4277A-11

S E R V I C E N O T E

HP 4277A LCZ Meter

Instructions on replacing A4Q10

Fig.1 New Transistor Mounting

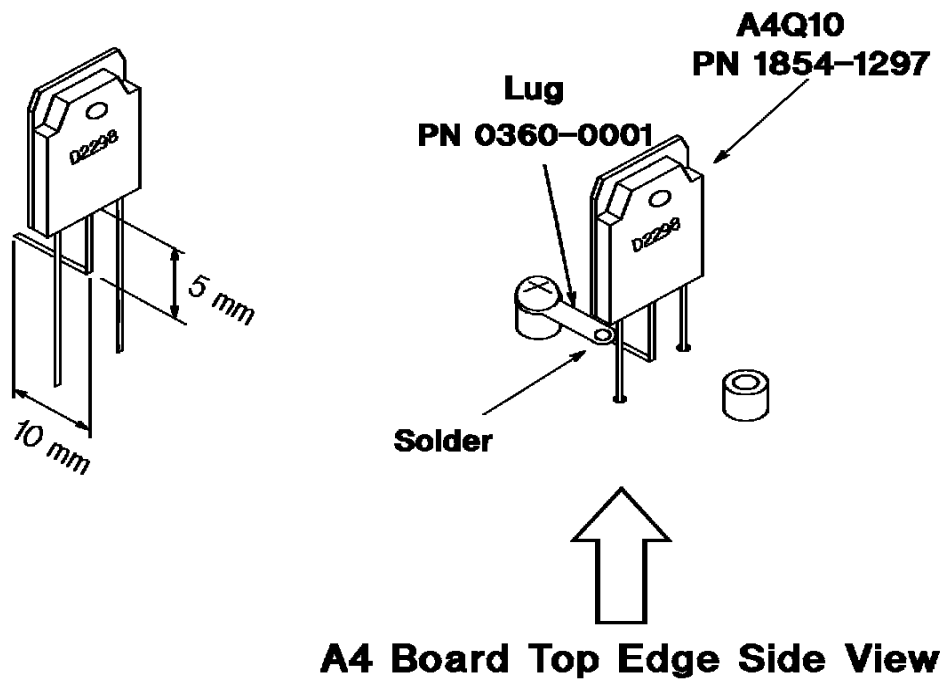
The power transistor A4Q10 on A4 power supply board has been changed. The new transistor has P/N 1854-1297 while the old transistor is no longer supplied has P/N 1854-0935. The shapes of the old and new transistors are different, so additional part and special instructions are required to install the new transistor on the old A4 board.

Install new transistor with lug as shown below.
